July 2023
SF655 A-E

Subject: Freightliner Cascadia and Western Star 47X/49X Fan Controller

Models Affected: Specific model year 2022 Freightliner Cascadia and Western Star 47X/49X vehicles, equipped with Cummins engines, manufactured from April 20, 2021, through October 6, 2021.

Daimler Truck North America LLC (DTNA), on behalf of its Freightliner Trucks Division and wholly owned subsidiary, Western Star Truck Sales, Inc., is initiating Field Service Campaign SF655 A-E to modify the vehicles mentioned above.

Fig. 1, Kysor Fan Control Module Location

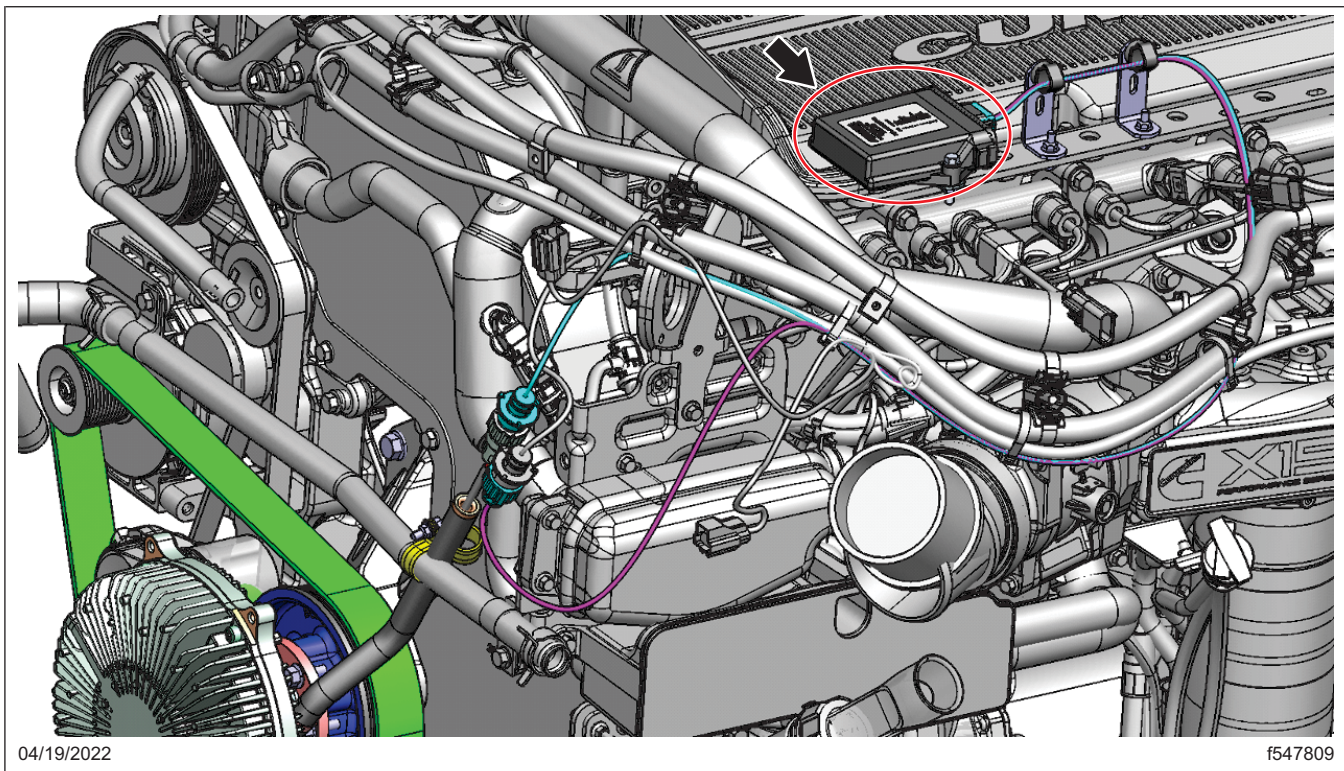
1. Check the base label (Form WAR259) for a completion sticker for SF655 (Form WAR261) indicating this work has been done. The base label is usually located on the passenger door about 12 inches (30 cm) below the door latch. If a sticker is present, no work is needed. If there is no sticker, proceed with the next step.
2. Park the vehicle on a level surface, shut down the engine, and set the parking brake. Chock the tires.
3. Locate the Kysor fan control module on the mounting bracket along the left-hand side of the engine rocker cover toward the front of the engine. See [Fig. 1](#).

Fig. 2, Kysor Fan Control Module Removal

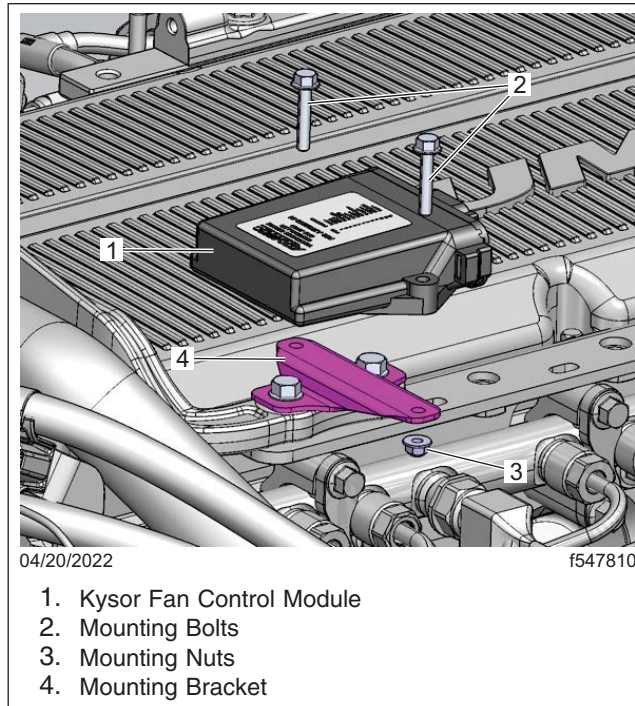
4. Disconnect the Kysor fan control module electrical connector.
5. Remove the two fasteners that attach the Kysor fan control module to the mounting bracket, then remove the fan control module from the vehicle, and discard it. See [Fig. 2](#).

6. Position the new Kysor fan control module on the mounting bracket, then install the two fasteners that attach the fan control module to the mounting bracket. Tighten the fasteners 60 to 72 lbf-in (678 to 813 N-cm).
7. Connect the electrical connector to the fan control module.
8. Clean a spot on the base label (Form WAR259) and attach a campaign completion sticker for SF655 (Form WAR261), indicating this work has been completed.

Fig. 3, Kysor Fan Control Module Location

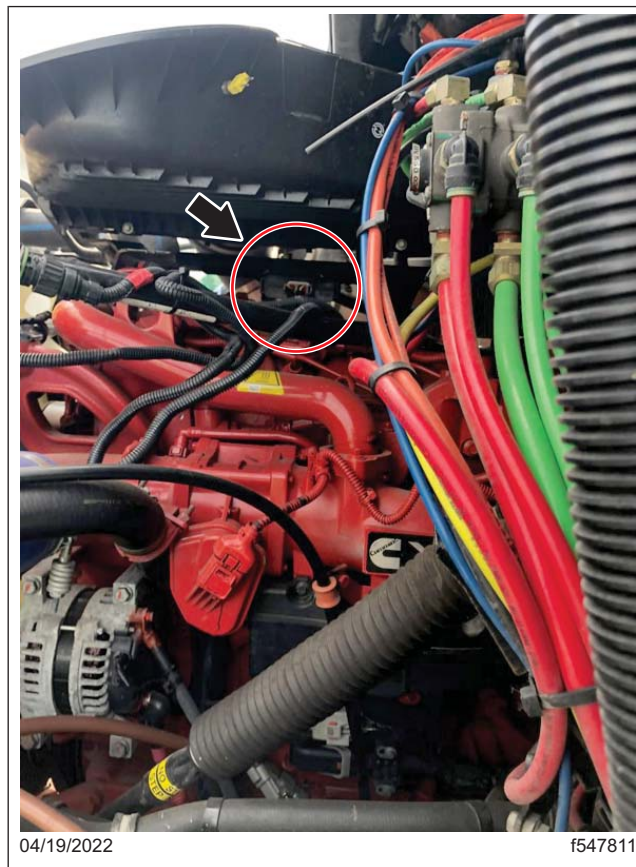
1. Check the base label (Form WAR259) for a completion sticker for SF655 (Form WAR261) indicating this work has been done. The base label is usually located on the passenger door about 12 inches (30 cm) below the door latch. If a sticker is present, no work is needed. If there is no sticker, proceed with the next step.
2. Park the vehicle on a level surface, shut down the engine, and set the parking brake. Chock the tires.
3. Locate the Kysor fan control module on the mounting bracket under the intake bracket above the rocker cover. See [Fig. 3](#) and [Fig. 4](#).

Fig. 5, Kysor Fan Control Module Removal

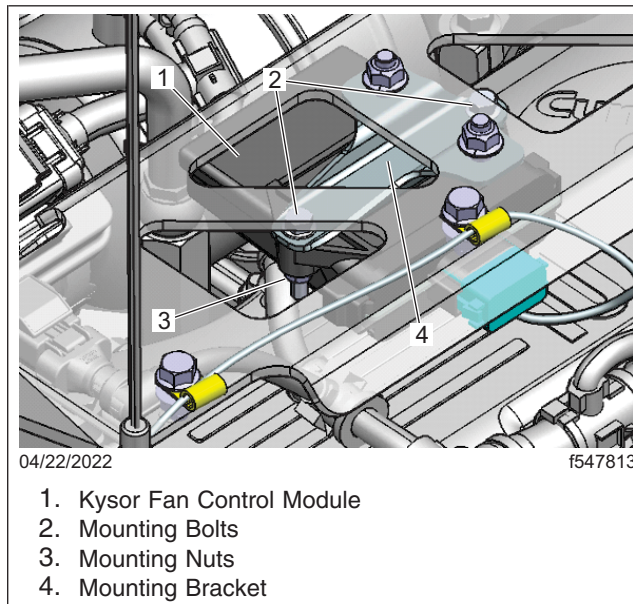
4. Disconnect the Kysor fan control module electrical connector.
5. Remove the two fasteners that attach the Kysor fan control module to the mounting bracket, then remove the fan control module from the vehicle, and discard it. See [Fig. 5](#).

NOTE: There may not be enough clearance between the module bracket and the intake bracket to remove the bolts. It is only necessary to remove the nuts from the bolts to replace the module.

6. Position the new Kysor fan control module on the mounting bracket, then install the two fasteners that attach the fan control module to the mounting bracket. Tighten the fasteners 60 to 72 lbf-in (678 to 813 N-cm).
7. Connect the electrical connector to the fan control module.
8. Clean a spot on the base label (Form WAR259) and attach a campaign completion sticker for SF655 (Form WAR261), indicating this work has been completed.

Fig. 6, Kysor Fan Control Module Location

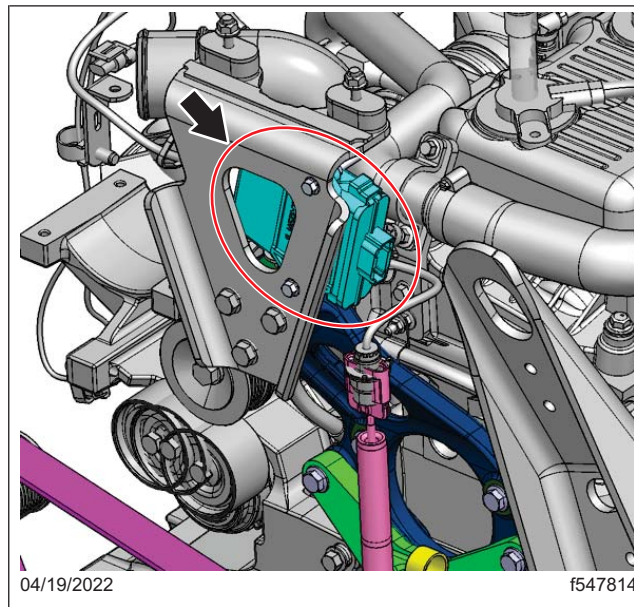
1. Check the base label (Form WAR259) for a completion sticker for SF655 (Form WAR261) indicating this work has been done. The base label is usually located on the passenger door about 12 inches (30 cm) below the door latch. If a sticker is present, no work is needed. If there is no sticker, proceed with the next step.
2. Park the vehicle on a level surface, shut down the engine, and set the parking brake. Chock the tires.
3. Locate the Kysor fan control module on the mounting bracket on the front of the engine near the top. See [Fig. 6](#)

Fig. 7, Kysor Fan Control Module Removal

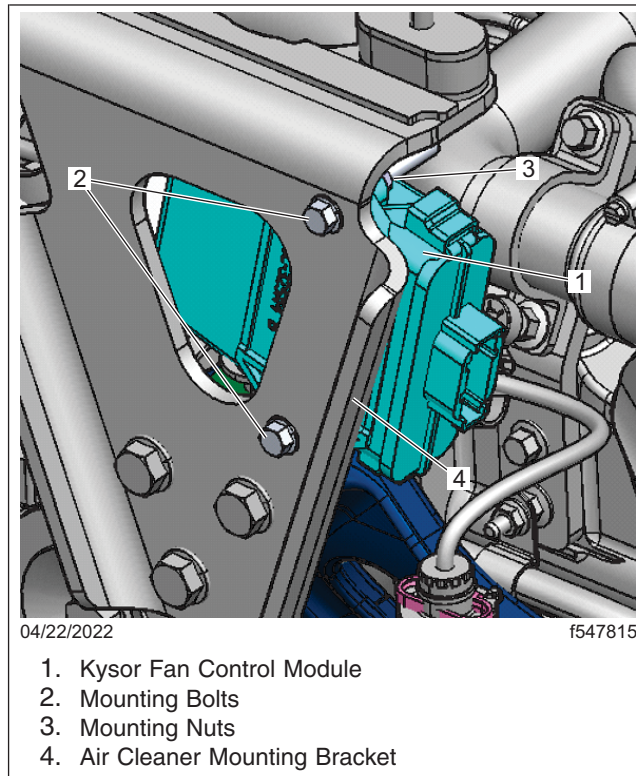
4. Disconnect the Kysor fan control module electrical connector.
5. Remove the two fasteners that attach the Kysor fan control module to the air cleaner mounting bracket, then remove the fan control module from the vehicle, and discard it. See **Fig. 7**.

6. Position the new Kysor fan control module on the air cleaner mounting bracket, then install the two fasteners that attach the fan control module to the air cleaner mounting bracket. Tighten the fasteners 60 to 72 lbf-in (678 to 813 N-cm).
7. Connect the electrical connector to the fan control module.
8. Clean a spot on the base label (Form WAR259) and attach a campaign completion sticker for SF655 (Form WAR261), indicating this work has been completed.
